### Discontinuation Notice of Square sockets of Model P2RF-E series.

**Model P2RF-05-E**  
**Model P2RF-08-E**

**Model P2RFZ-05-E**  
**Model P2RFZ-08-E**

[ Body color ]

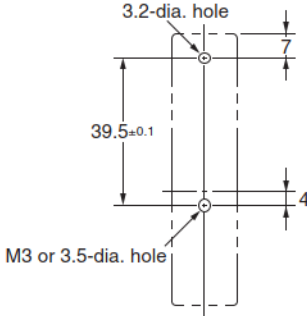
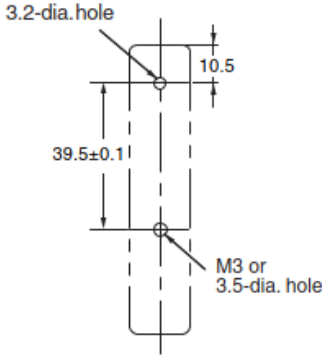
Product discontinuation Model P2RF-05-E Model P2RF-08-E	Recommendable replacement Model P2RFZ-05-E Model P2RFZ-08-E
<p>Body color : Light gray</p> <p>P2RF-05-E                      P2RF-08-E</p> 	<p>Body color : Black</p> <p>P2RFZ-05-E                      P2RFZ-08-E</p>

[ Wire connection ]

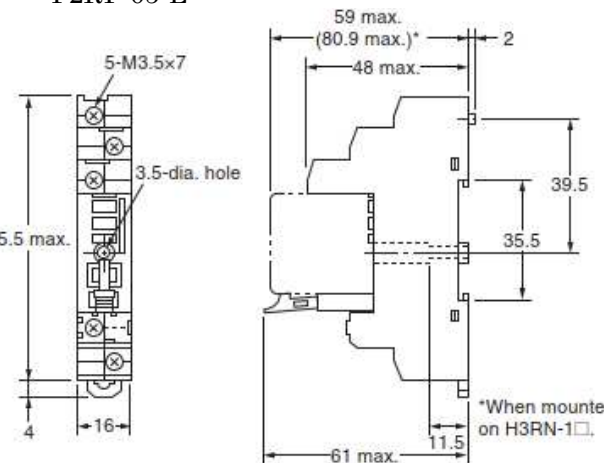
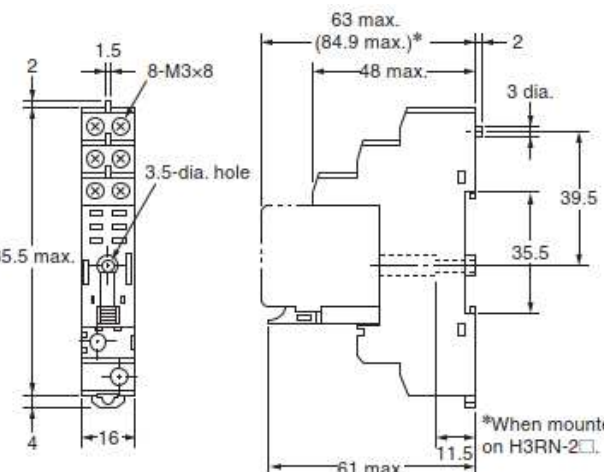
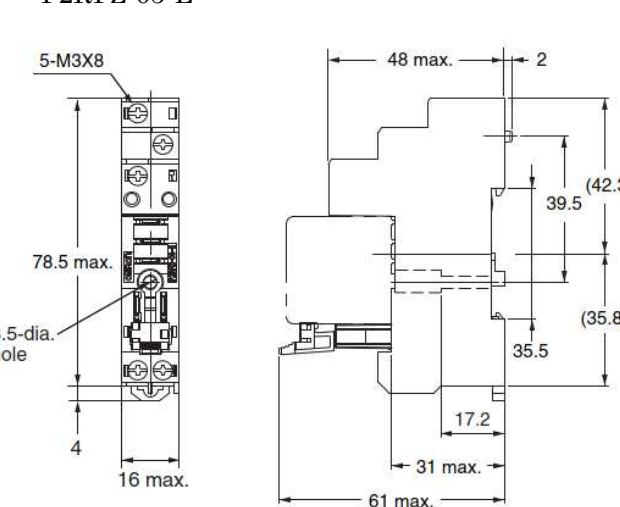
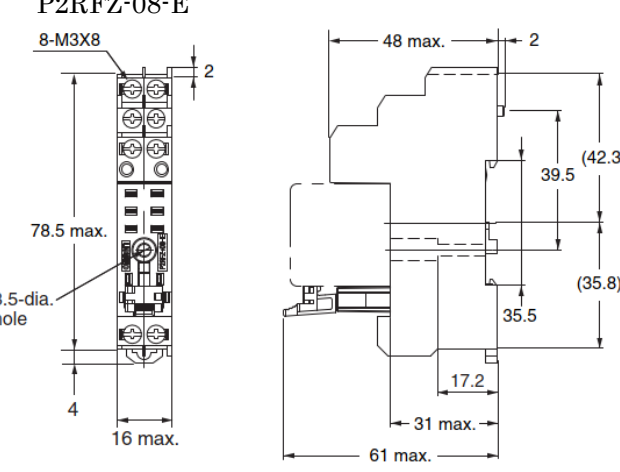
Product discontinuation Model P2RF-05-E Model P2RF-08-E	Recommendable replacement Model P2RFZ-05-E Model P2RFZ-08-E
<p>P2RF-05-E                      P2RF-08-E</p>  <p>(TOP VIEW)                      (TOP VIEW)</p>	<p>P2RFZ-05-E                      P2RFZ-08-E</p>  <p>(Top View)                      (Top View)</p>

[ Mounting dimensions ]

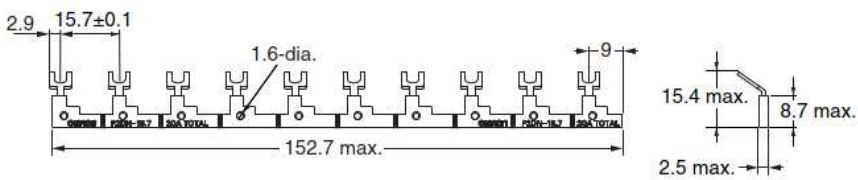
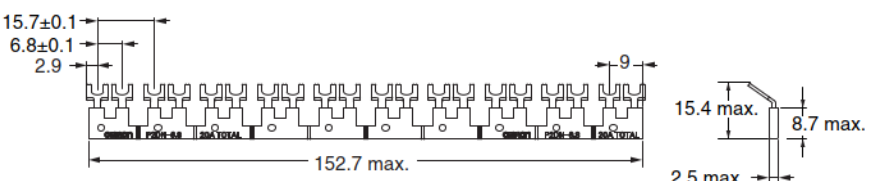
Product discontinuation Model P2RF-05-E Model P2RF-08-E	Recommendable replacement Model P2RFZ-05-E Model P2RFZ-08-E
 <p>(Top View)</p>	 <p>(Top View)</p>
